April 4, 2002

TO ALL EXEC, EXEC 90, AND EXEC 162F OWNERS

ADVISORY BULLETIN A-37

Template to determine angle of control arm (not to scale). Measure throttle shaft to rod end distance on control arm, use measurement for drilling holes in template.

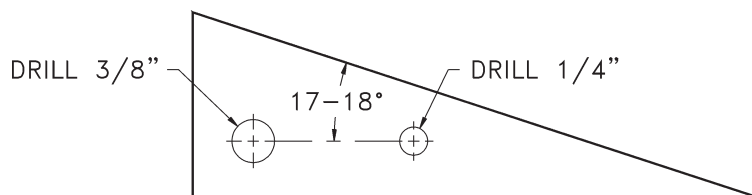
History: Proper throttle linkage adjustment should prevent binding or restriction of movement. It has been found that if the stop bracket and/or "B" control arm is improperly adjusted on the pilot's collective control, the passenger's throttle action may lock up.

1. At full off throttle, the "B" control arm at the end of the pilot's collective handle should be at an angle of 17 to 18 degrees in reference to the collective cross shaft.
2. The metal stop bracket on the pilot's collective handle should contact the "B" control arm.
3. The throttle connector cross shaft should contact the passenger throttle shaft. (Refer to the drawing below for rear view of collective cross shaft and throttle linkage, and template to determine "B" control arm angle.)

Action: If "B" control arm on pilot's side collective is less than 17 to 18 degrees, the throttle connector cross shaft should be lengthened by unscrewing the rod ends, then the angle should be rechecked. If the throttle stop does not contact the "B" control arm, it should be adjusted by bending the throttle stop so that it does contact the "B" control arm.

To use template: With throttle in full closed position the angle should be 17-18° in reference to the collective cross shaft (template is level).
